# SERVICE BULLETIN

Technical Service Bulletin: 51-0780

## EN Absorption Refrigerators Door Latch Strike Covers Service Kit Installation

**Absorption Refrigerators**  
Service Bulletin

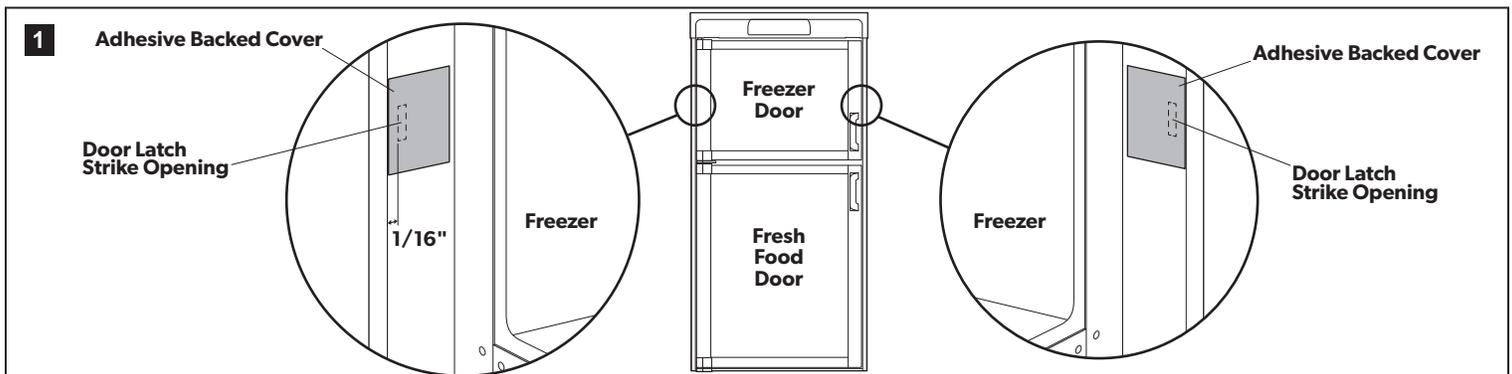
We have been able to identify a visual cosmetic defect that has occurred on our Dometic DM2652 refrigerators up in the freezer compartment. This does **NOT** occur on all units but may be present on units with serial numbers starting with MB between 805xxxxx and 820xxxxx.

The visual cosmetic defect is that extra door latch strike openings have been punched in the refrigerator frame, and during the assembly process the extra door latch strikes were not installed (please see the illustrations below.) The foam sealing strip, required by ANSI/NFPA 1192 and ANSI Z21.19, is provided to seal the refrigerator against the cabinetry when it is installed into the RV. Although the omission of the door latch strikes leaves small cosmetic openings that can be seen visually, the foam sealing strip located behind the door latch strike openings at the freezer provides a seal to maintain complete separation of the combustion system from the interior atmosphere of the recreational vehicle, as stated in ANSI/NFPA 1192.

- Remove one adhesive backed cover from the paper backing and install the cover over one of the door latch strike openings using the following guidelines:
  - The area in which the adhesive backed cover will be applied must be clean and free of any residue that will impact the ability of the cover to adhere properly.
  - The adhesive backed cover must completely cover the door latch strike opening and extend towards the front edge of the refrigerator frame by at least 1/16".
  - The adhesive backed cover must be centered vertically over the door latch strike opening.
- Once the cover is in place, apply light pressure across the surface of the cover to ensure that the cover firmly adheres to the refrigerator frame.
